AN/SM/JBu
16457
28 June 2017

**SECTION 75W MODIFICATION (MOD 8) - MP08_0238
1 DENISON STREET, NORTH SYDNEY**

Figure 2 – Approved basement section (MOD 6)
Source: Bates Smart

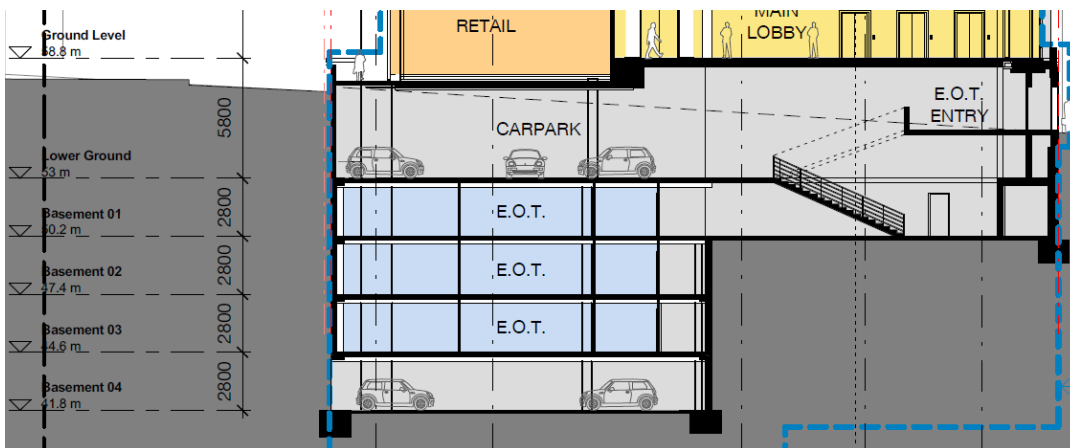
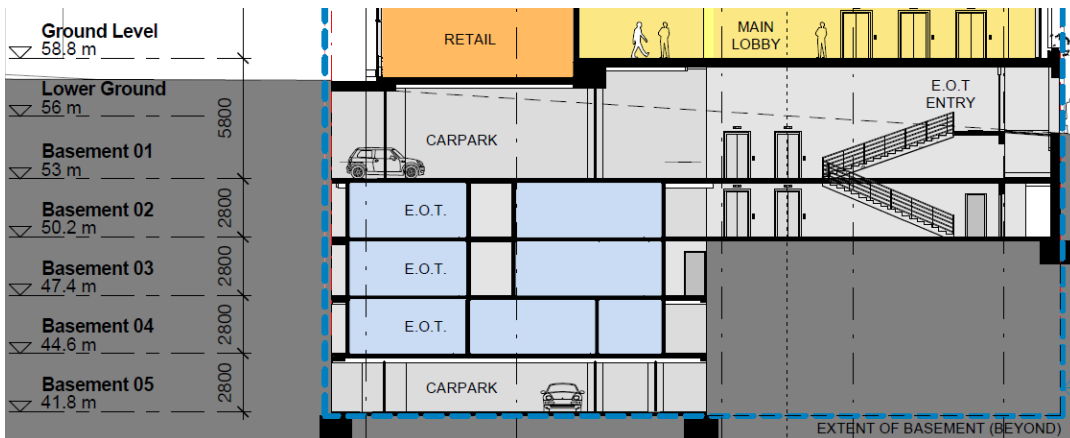
The proposed basement changes introduce a lower ground void and servicing level on plan. Whilst this results in a renumbering of the basement plans, it does not change the extent of the approved basement, the provision of parking, the finished ground level, or the extent of excavation. The proposed renumbering is as follows:

- Approved Ground Level = Proposed Ground Level
- New plan = Proposed Below Ground Level (plant and servicing only)
- Approved Lower Ground Level = Proposed Basement 01
- Approved Basement 01 = Proposed Basement 02
- Approved Basement 02 = Proposed Basement 03
- Approved Basement 03 = Proposed Basement 04
- Approved Basement 04 = Proposed Basement 05

A comparison of the basement depths, demonstrating no change, is provided at **Figure 2** (Basement as approved in MOD 6) and **Figure 3** (basement as proposed in MOD 8), noting that the RL of the deepest basement level is maintained at RL41.8.

Figure 5 – East elevation, with approved building envelope outlined in blue
Source: Bates Smart

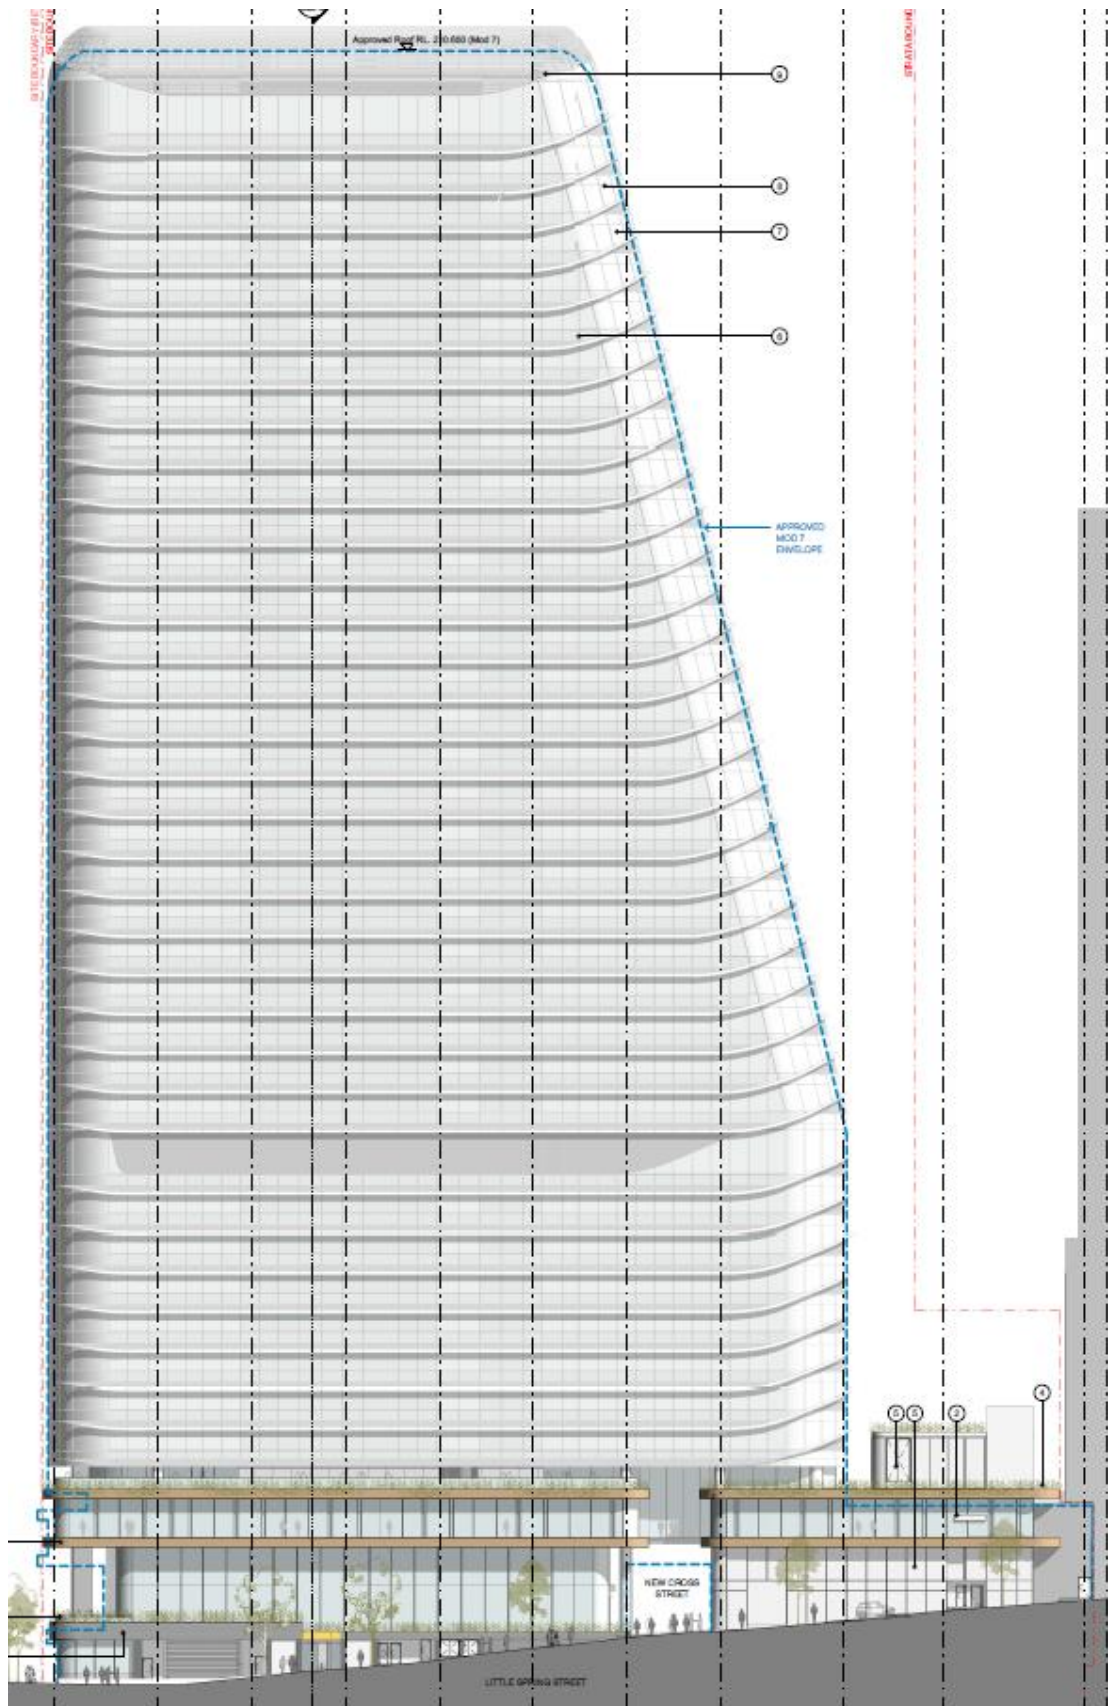
The proposed modification will result in a minor decrease in building separation between the existing mixed use development at 77 Berry Street, Beau Monde, and the 1 Denison Street building. As the ground floor of the building is proposed to be elevated by 2.2m in order to accommodate the requirements of the anchor tenant’s production spaces, the resultant building taper will commence at a greater elevation, which will result in minor changes to the level-by-level setbacks.

As illustrated in **Figure 5** below, the minor changes to building setbacks are negligible. The modification will continue to provide a slender tower form, with greater setbacks from the adjacent residential tower as the building increases in height, and will retain the approved privacy screening measures in the façade design to prevent direct views between buildings. The modification remains generally consistent with the approved building lines to safeguard the privacy of adjoining residential development.

Figure 6 – View sharing from Level 15 of the Beau Monde Tower
Source: Virtual Ideas

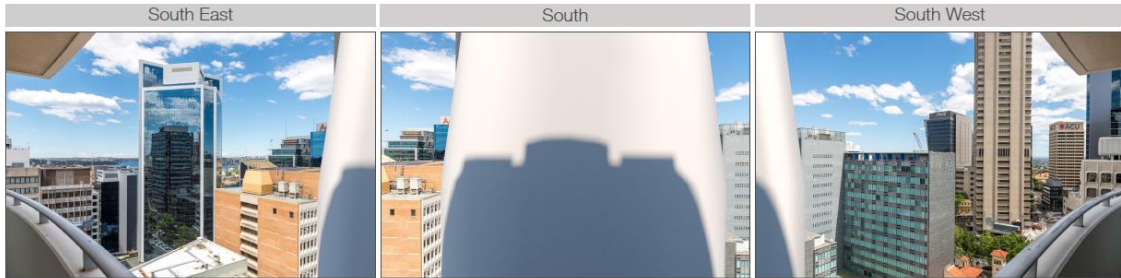
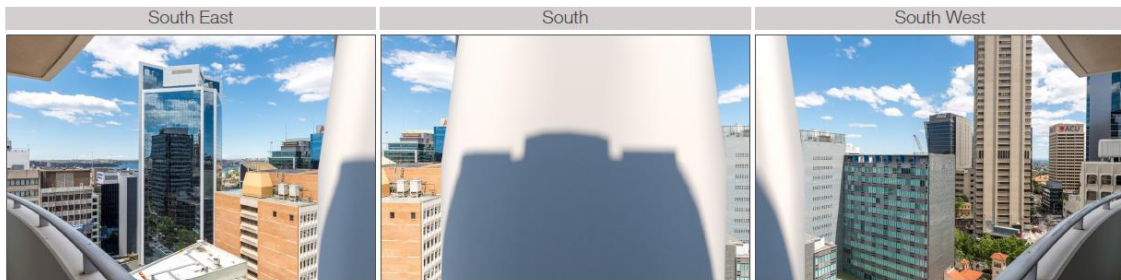
The proposed changes to the floor to floor heights at lower levels, and the resultant minor change to the overall building height, will marginally alter the view lines from residential apartments adjoining the Site to the north. A revised Visual Impact Study has been prepared by Virtual Ideas and is submitted at **Attachment C** and replicated at **Figure 6-9** below.

It is evident that these changes are minor in nature, and that the proposed modification will not alter the view impacts of the development on adjoining residential properties.
